County of San Diego
Planning & Development Services
BUILDING DIVISION

ACCESSIBILITY CORRECTION LIST

Public Accommodations
& Commercial Buildings

Mercantile and Retail Uses

FIGURE 11B-903.4
BENCH BACK SUPPORT

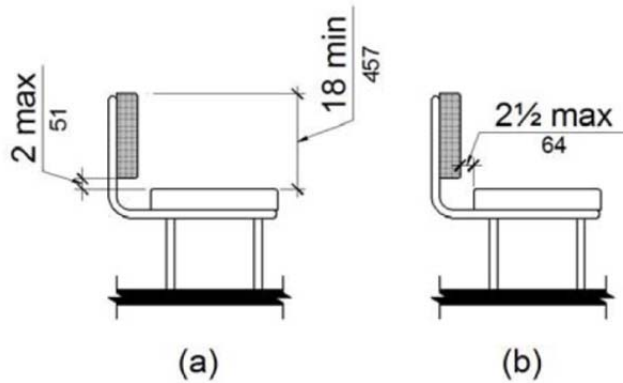
9. Identify at least 5% of fitting rooms provided – but not fewer than one for each room type (e.g., female, male, unisex) – as accessible and complying with items 10 through 13.
- CBC 11B-222 and CBC 11B-803
10. Dimension minimum 60-inch diameter or equivalent T-shaped space per CBC 11B-304.3.2 within each accessible fitting room.
- CBC 11B-304 and CBC 11B-803.2
11. Detail at least one bench per the following:
- ☐ Minimum 48 inches long
 - ☐ Minimum 20 inches and maximum 24 inches deep
 - ☐ Minimum 48-inch-long back support per CBC Figure 11B-903.4
- Exception:** Bench affixed to wall along its long dimension
- ☐ Mounted minimum 17 inches and maximum 19 inches above finished floor
 - ☐ Minimum 30-inch-wide by 48-inch-long clear space provided at end of bench seat and parallel to short axis of bench
 - ☐ Structural adequacy to support 250-pound point load
